Airport Land Use Commission

MEMORANDUM:

Subject: Item 7: ALUC-11-07 - Proposed Shiloh IV Wind Energy Project (enXco)

Conduct a Public Hearing on a Request for a Land Use Compatibility Determination for Shiloh IV, a commercial wind energy project to be installed on approximately 3,012 acres of combined agricultural parcels in the Montezuma Hills wind resource area south of Highway 12 in the Montezuma Hills. (Applicant: enXco) (Sponsor: County of Solano)

Figure 1: Proximity of Shiloh IV to Travis Air Force Base

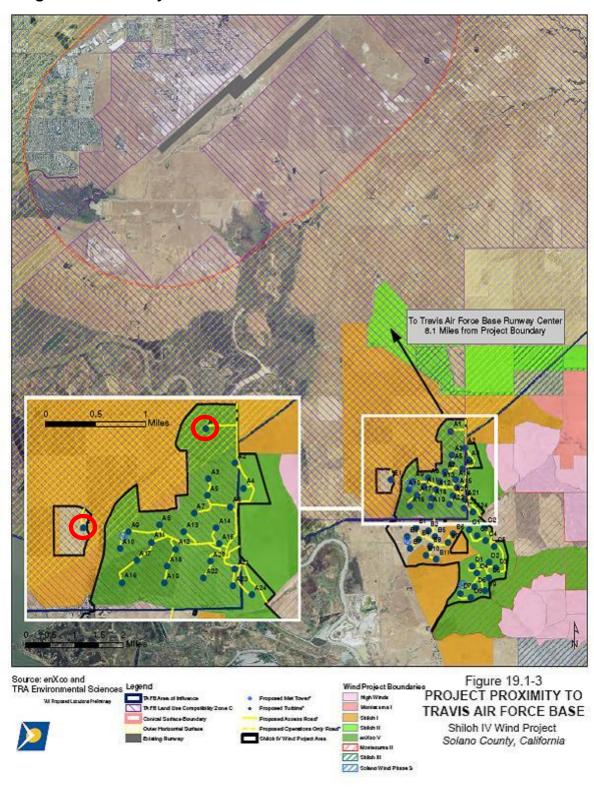
Most of the project lies outside the outer boundary of the Part 77 area and thus is not inconsistent with this provision. Two turbines, circled in red on Figure 1 are within the Part 77 Surfaces boundaries, under the uppermost horizontal surface.

The height limit for the horizontal surface is 562' above Mean Sea Level. The applicant is utilizing 70 meter towers for these two turbines in order to keep their maximum height under the 562 'MSL height requirement. The FAA has issued No Hazard determinations for the project, including these two towers.

Staff recommends finding the project consistent with this provision.
